San Francisco Peninsula Rail Program

To: Executive Steering Committee
From: Alfonso Rodriguez, DTX Project Director
Date: December 16, 2022
Re: Item 6, Action Item:
Consider Recommending the Addendum to the Transbay Program 2018 Final Supplemental Environmental Impact Report and Revised Mitigation Monitoring and Reporting Program under the California Environmental Quality Act (CEQA), and Modifications to the Downtown Rail Extension Project Analyzed Therein

Addendum to the Transbay Program 2018 Final Supplemental Environmental Impact Report

Figure 2-2. Approved BART/Muni Pedestrian Connector to be Deferred

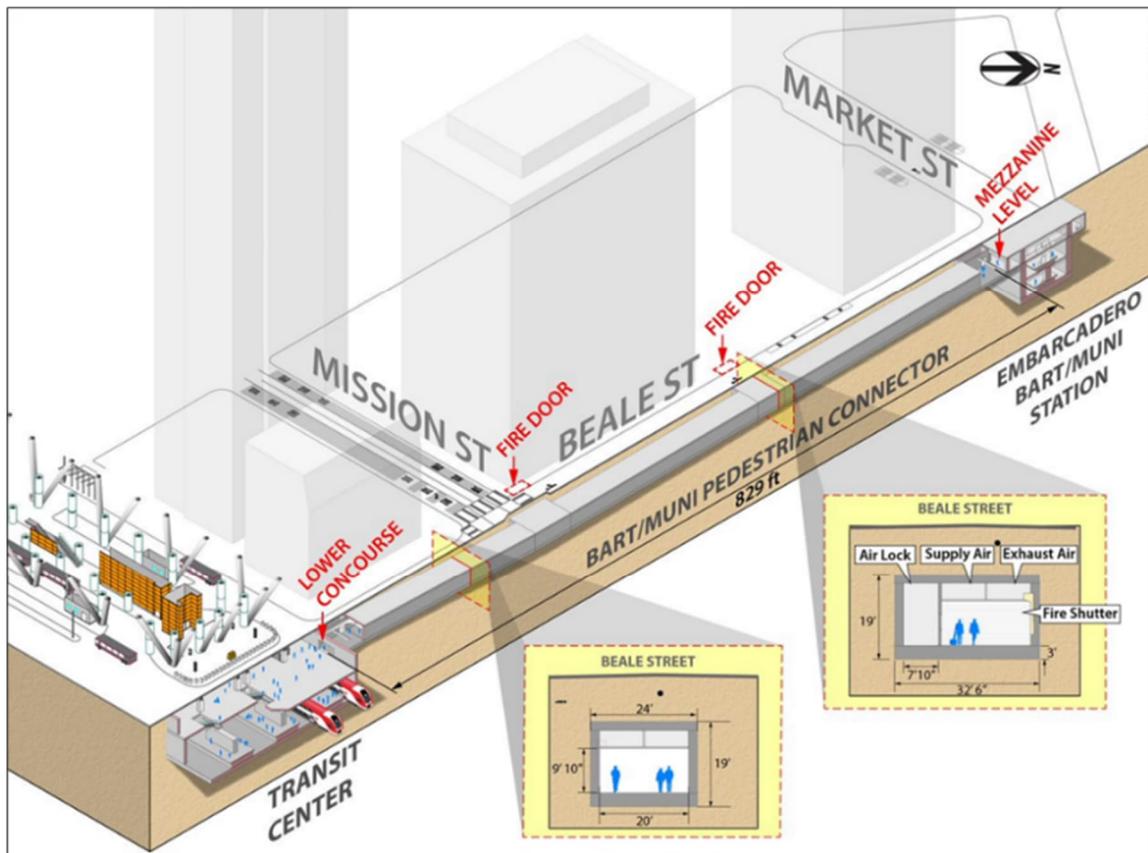
The TJPA would not construct the underground pedestrian connector analyzed in the 2018 Final SEIS/SEIR until station improvements were made at the Embarcadero BART/Muni

Description and Objective of Proposed Revision. During preparation of the 2020–2021 Transbay Program Downtown Rail Extension Phasing Study (TJPA 2021), BART staff sent a letter to the TJPA expressing no objection to the deferral of the pedestrian connector, because BART's evaluation of the Embarcadero BART/Muni Metro Station capacity was in progress. BART conducted planning work on potential options to resolve (pre-pandemic) overcrowding issues at the Embarcadero BART/Muni Metro Station, which would involve station platform modifications, and therefore would affect the approved pedestrian connector. Also, BART, in partnership with the Capitol Corridor Joint Powers Authority, has begun studying a regional rail connection from the East Bay (known as Link21) that may include a station in San Francisco to address these capacity issues. BART indicates that the studies and possible station and transbay crossing concepts will be evaluated pursuant to NEPA and CEQA approximately in the 2024–2027 timeframe. Deferral of the pedestrian connector would allow BART to develop a plan to incorporate a pedestrian connection in concert with capacity-enhancing station modifications at the Embarcadero BART/Muni Metro Station.

Figure 2-3. Proposed Reduced Train Box Extension

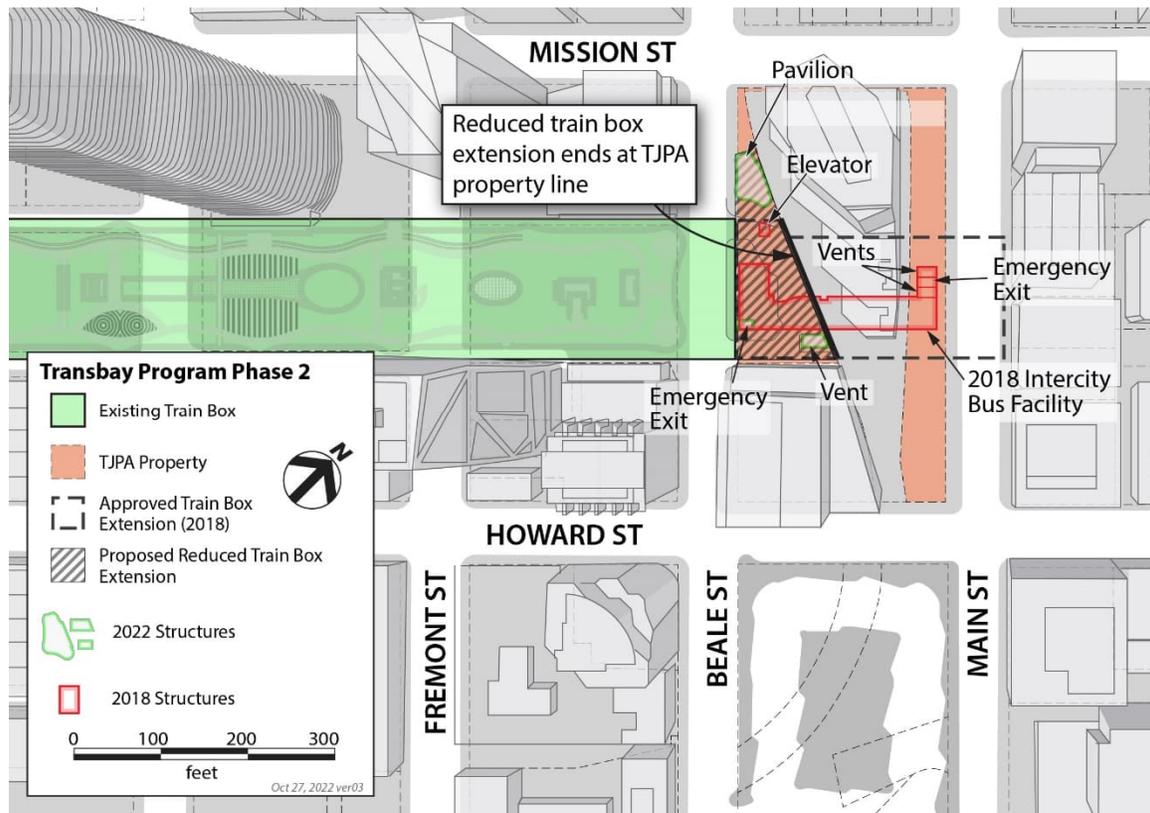
Therefore, the TJPA proposes to reduce the extension of the train box that was approved in the 2018 Final SEIS/EIR by approximately 250 feet (Figure 2-3). With this reduction, the train box extension would end at the TJPA property line just east of Beale Street. As a

result of this reduction, no land acquisition would be required for this project component, and demolition of the lower podium portion of the building at 201 Mission Street would not occur. As part of the reduction, the vent structure and emergency exit that had been approved as part of the extended train box at the Transit Center would be relocated to the TJPA parcel just east of Beale Street across from the Transit Center as shown in Figure 2-3.

Figure 2-4. Approved Intercity Bus Facility

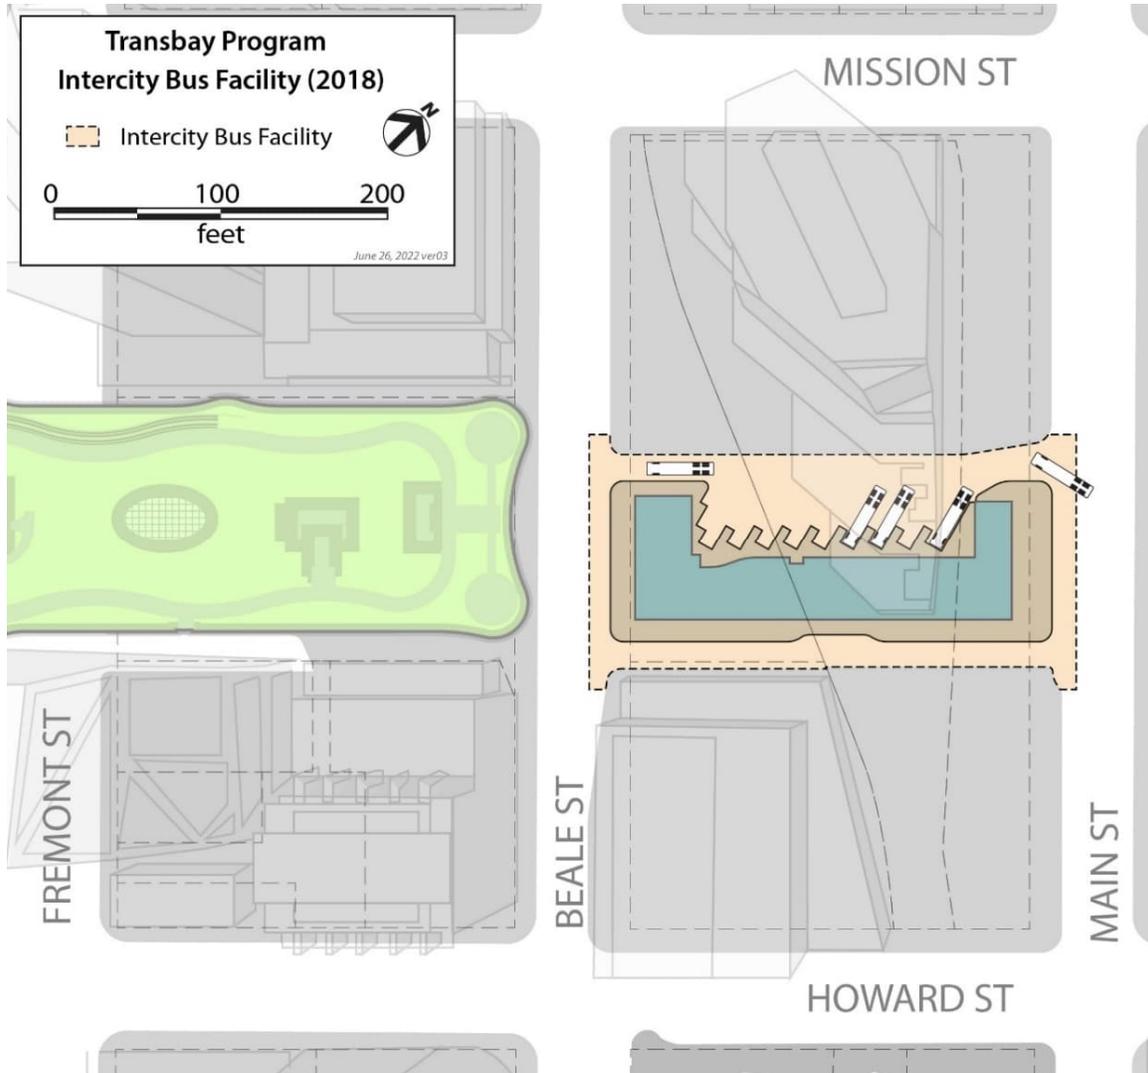
Description and Objective of Proposed Revision. AC Transit anticipates that it will need to expand its use of the bus deck between 2035 and 2050. Currently, AC Transit leases two bus bays to Greyhound, with shared use of a third bay and an additional bus bay leased to WestCAT. Greyhound has a separate lease agreement with the TJPA for approximately 4,500 square feet of the Transit Center, for its office/ticketing area, package express operations, and passenger waiting area. Both of Greyhound's lease agreements will expire on August 31, 2029.

In addition, the approved intercity bus facility would have provided access to the Transit Center station below. With the deferral of this facility, a new street-level entrance/exit pavilion to the Transit Center would be constructed on the TJPA parcel along Beale Street, immediately north of the site for the intercity bus facility, as shown in Figure 2-3.

Figure 2-5. Approved Taxi Staging Area at the Intercity Bus Facility to be Removed

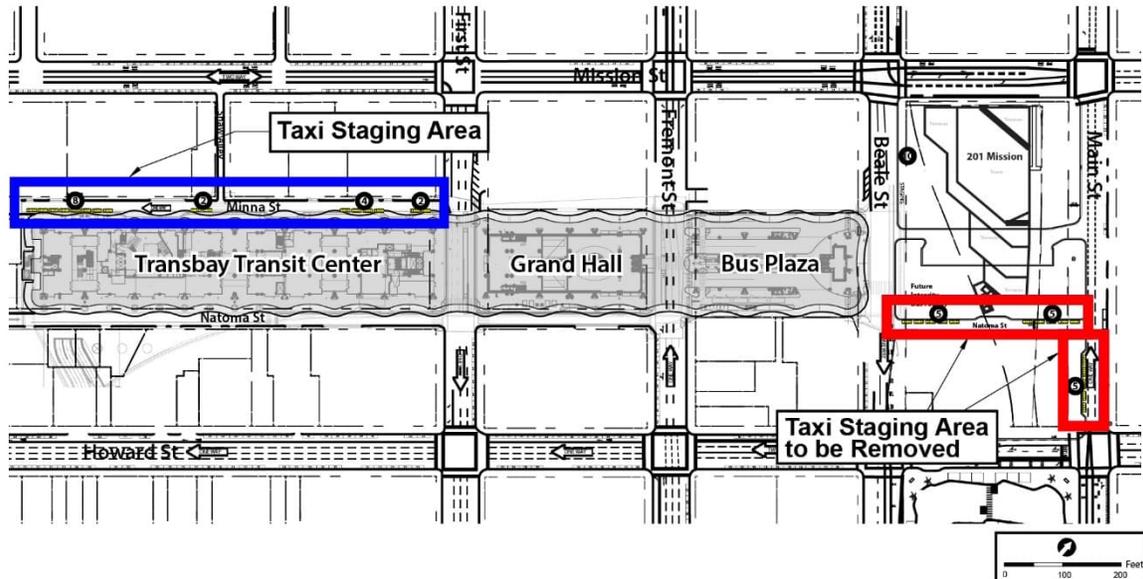
Description and Objective of Proposed Revision. Because of the deferral of the intercity bus facility and the reduced size of a future intercity bus facility as described above, no space would be available for a taxi staging area a smaller intercity bus facility. In addition, a taxi staging already is adjacent to the Grand Hall on Minna and Natoma Streets. Further, an increasing percentage of vehicle trips are performed by Transportation Network Companies that provide alternative taxi type service at designated pickup and drop off areas along Mission Street and Howard Street, around the Transit Center. Therefore, the Revised Project would remove the approved taxi staging area at the intercity bus facility.

Figure 2-6. Approved Three-Track Tunnel Segment to be Converted to Two Tracks

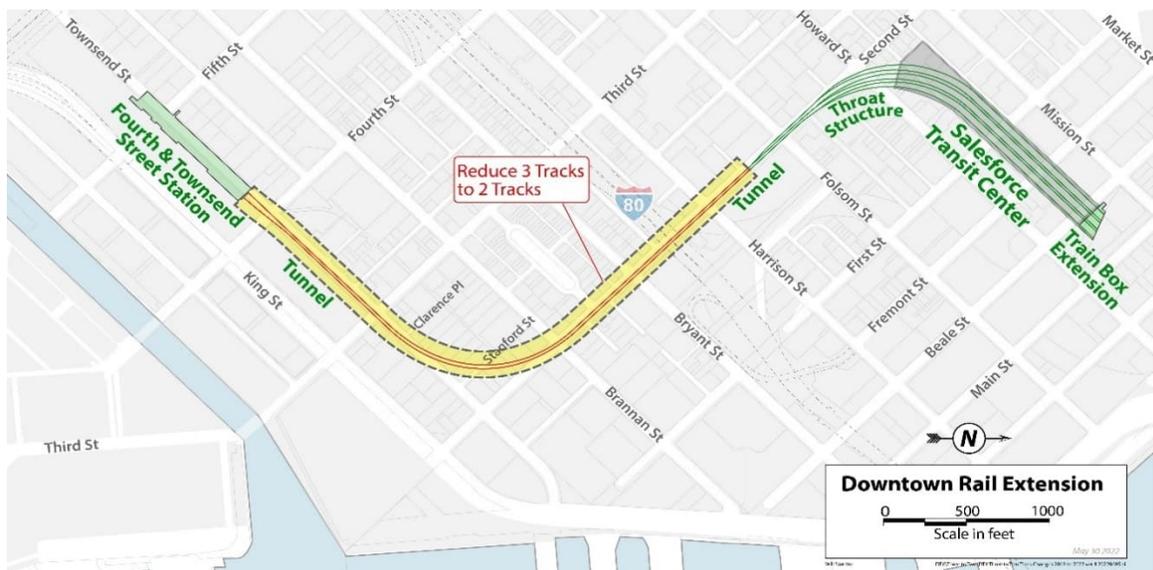
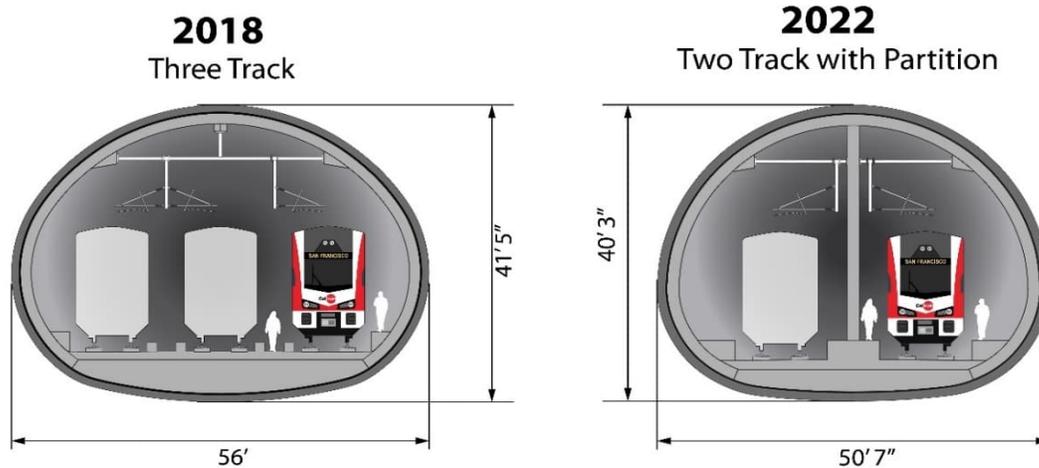
Description and Objective of Proposed Revision. An updated operations analysis was conducted as part of the phasing study analysis in 2020, conducted by Deutsche Bahn International on behalf of Caltrain and CHSRA, to validate infrastructure requirements as new information regarding the rail operators' vehicles and operating plans were defined, and to determine whether the track configuration could be optimized to enhance rail service and/or result in reduced project costs. As part of this updated operations analysis, a longer two-track section and reduced three-track section in the tunnel were recommended, together with a proposed modification of the Fourth and Townsend Street Station design (described next).

In this configuration, the three-track section of the tunnel that would be reduced to two tracks would begin mid-way between Harrison and Folsom Streets along Second Street, continue south along Second Street, and then east along Townsend Street to Fourth Street (Figure 2-6). Approximately 3,900 feet of the approved three-track configuration in the tunnel would be replaced with two tracks as part of this proposed change in design. The width of tunnel for this 3,900-foot segment would decrease from 56 feet wide to less than 51 feet wide, which also would reduce the permanent easement width in this segment (Figure 2-7). The amount of excavation also would decrease by 67,000 cubic yards because of the reduced tunnel width in this segment.

Figure 2-10. Proposed Modifications to Fourth and Townsend Street Station Design – Transverse Section of Change in Station Platforms

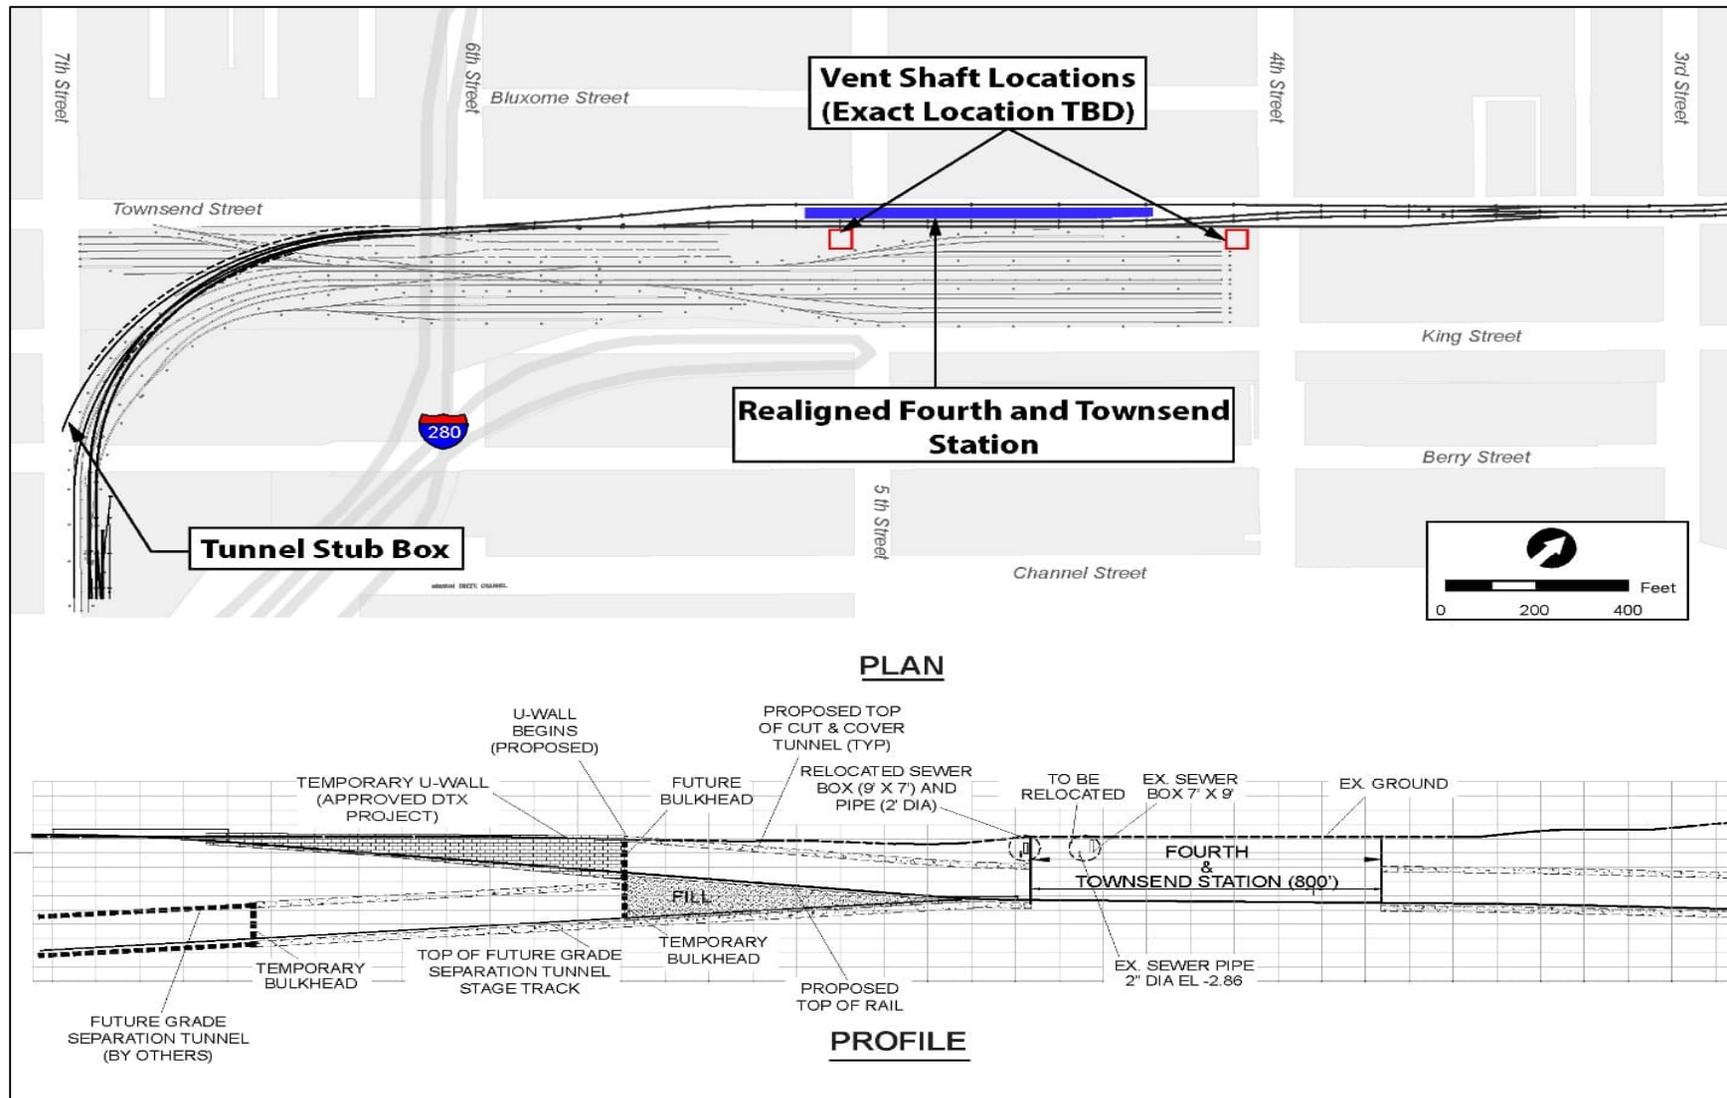
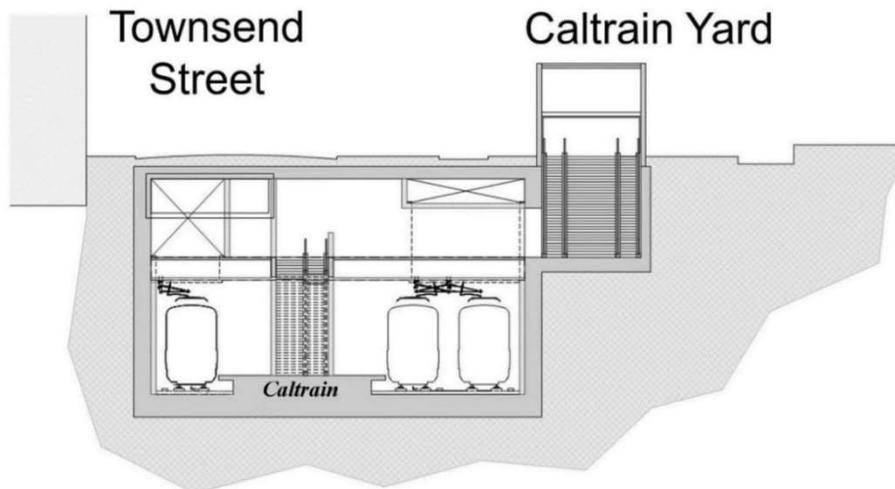
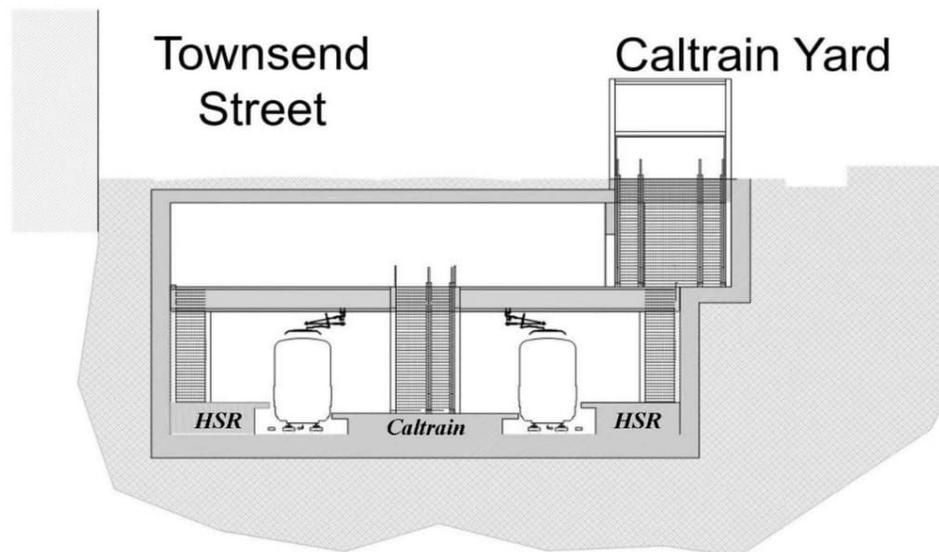
Description and Objective of Proposed Revision. CHSRA has determined that high-speed trains would stop at the Fourth and Townsend Street Station (CHSRA 2020 and 2022a). The station layout and trackwork would be modified to include two tracks serving one center platform for Caltrain passengers and two side platforms serving CHSRA passengers (Figure 2-10). The modified Fourth and Townsend Street Station design would allow service for both Caltrain and CHSRA with dedicated platforms, eliminating conflicting inbound and outbound train movements in the throat section and enabling the reduced three-track segment in the tunnel as described above. To maintain Caltrain as the regional rail service and support high-speed rail (HSR) as the intercity rail service, HSR trains would disembark passengers at the Fourth and Townsend Street Station on northbound (inbound) trips toward the Transit Center, but would not pick up passengers at the Fourth and Townsend Street Station. Northbound Caltrain riders could transfer to a southbound HSR train at the Fourth and Townsend Street Station, but would remain on Caltrain if headed north (to the Transit Center). In the opposite, southbound (outbound) direction (away from the Transit Center), HSR trains would pick up passengers at the Fourth and Townsend Street Station, but passengers would not be able to disembark. The changes to the trackwork, the addition of platforms for HSR service, and the operational analysis were reviewed and endorsed by the Integrated Program Management Team.

The addition of the platforms for high-speed trains would widen the station box, compared to the approved station. Along the 1,000-foot-long southern perimeter of the station box, certain sections would encroach approximately 4 feet further while other sections would encroach 16 feet further into the Caltrain railyard, creating a more rectangular footprint than the approved station box. The approved station design was irregularly shaped along its southern limits with the Caltrain railyard because structures for vertical circulation (i.e., stairs, escalators, elevators) and vent structures extended beyond the station train box. With this proposed change, the resulting encroachment and land acquisition would be approximately 0.29 acre more than for the approved station. The sections that would encroach approximately 4 feet further into the Caltrain railyard would be for the vertical circulation and vent structures, as shown in Figure 2-11. The 2018 approved project acknowledged that the siting of the vent structures was “to be determined” and was only generally identified. The current plans identify the vent structure sites more precisely, and the resulting shift has been conservatively analyzed as 4 feet further south than previously evaluated in the 2018 Final SEIS/EIR. The vent structure at the eastern end of the station would also be sited further to the west within the revised station footprint. The modified Fourth and Townsend Street Station, which would widen the station approximately 16 feet and lower it 4 feet (at the west end) to 11 feet (at the east end), would require an additional 50,200 cubic yards of excavation and disposal of spoil material, compared to the approved project.
